CONTRACT: DB00199  
TIP NUMBER: K-5101  
WBS ELEMENT: 42229.3.FS1  
COUNTY: Craven  
ROUTE: US 70  
DESCRIPTION: Rest Area Renovation  
**PRE BID NOTES & ADDENDUM #2**

Please note the following addendum to the proposal, notes from the pre-bid meeting, and responses to requests for information for the above-referenced project.

SHEET NO:  
**L2**  
 TOTAL SHEET NO: 8

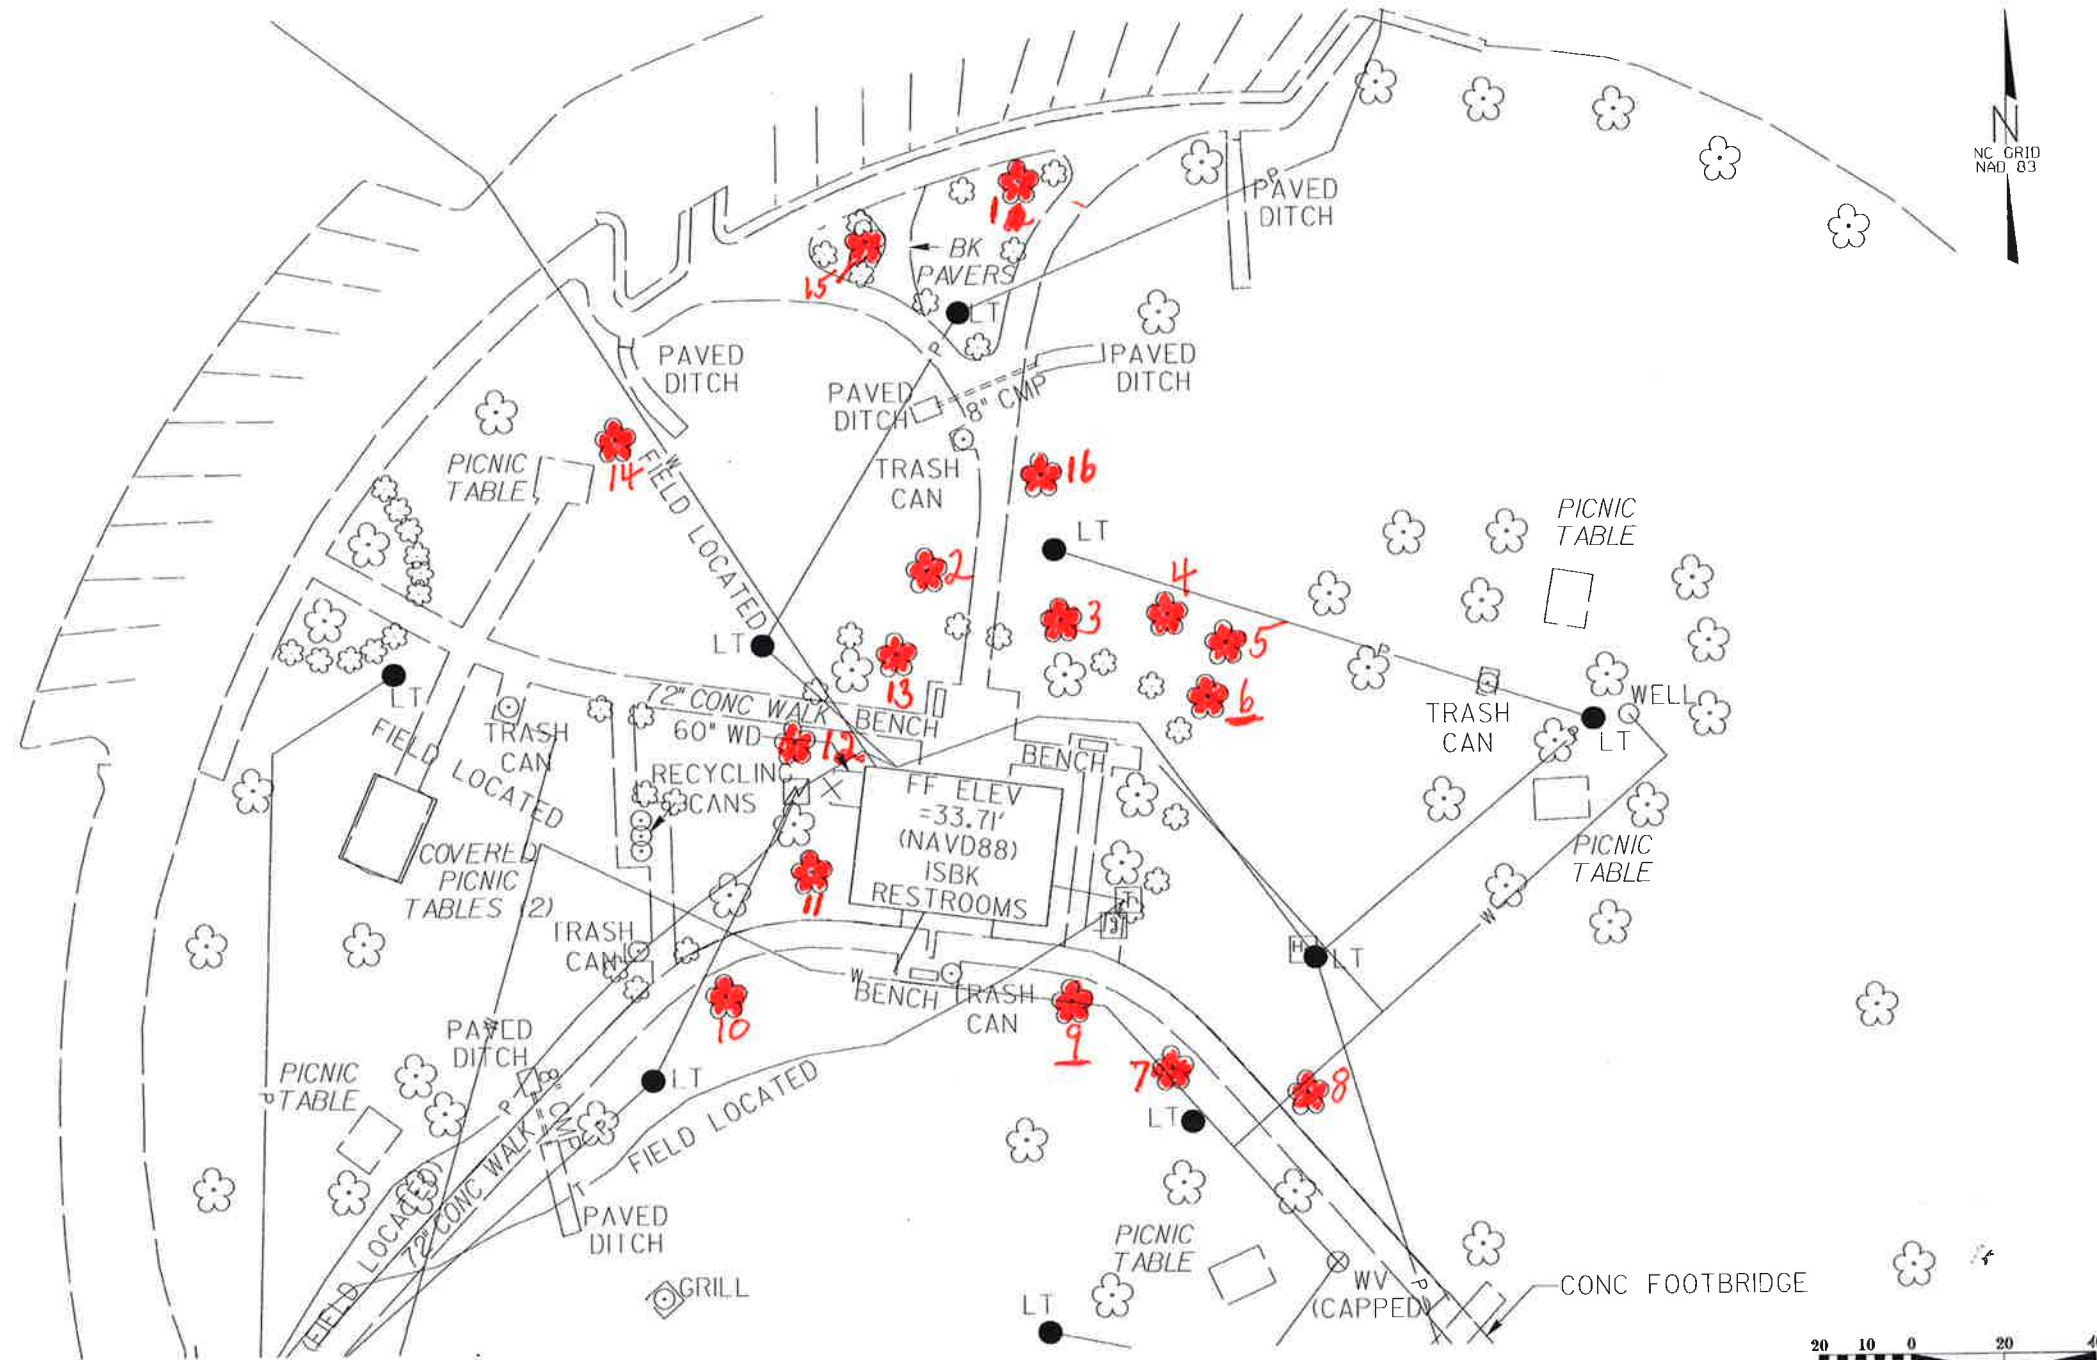
4. *How do we know which trees are to be removed so we can properly bid the project?*

The trees to be removed are identified on the attached plan sheet and are described by their diameter on the attached table. They have also been marked on site.
